**ASHLAND PLANNING DIVISION
PRE-APPLICATION CONFERENCE
COMMENT SHEET**

March 19, 2025

SITE: 1348 & 1382 Ashland Mine Rd.
APPLICANT: Rogue Planning for Lecomte
and Village Keeper
REQUEST: Annexation, Outline Plan
PSO Subdivision

Exceptions:

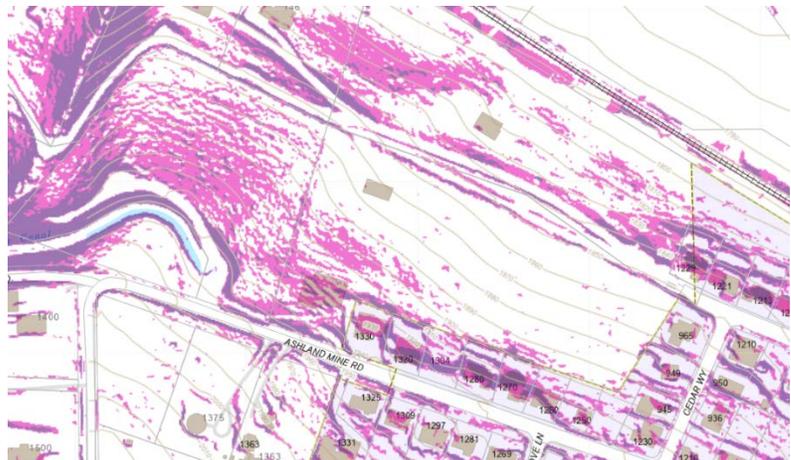
The following remarks are from the Fire Marshal: For subdivisions with 30 or more units, two fire apparatus access roads are required with remoteness. The exception is if all of the houses are sprinklered. Based on the grade of the road Fire will be asking for all homes to be sprinklered regardless (Uniform Alternate Construction Standard). If they sprinkler all of the homes, Fire can't require a second access road even though we would like one.

- 1. Where there are more than 30 dwelling units accessed from a single public or private fire apparatus access road and all dwelling units are equipped throughout with an approved automatic sprinkler system in accordance with Section 903.3.1.1, 903.3.1.2 or 903.3.1.3, access from two directions shall not be required.*
- 2. The number of dwelling units accessed from a single fire apparatus access road shall not be increased unless fire apparatus access roads will connect with future development, as determined by the fire code official.*
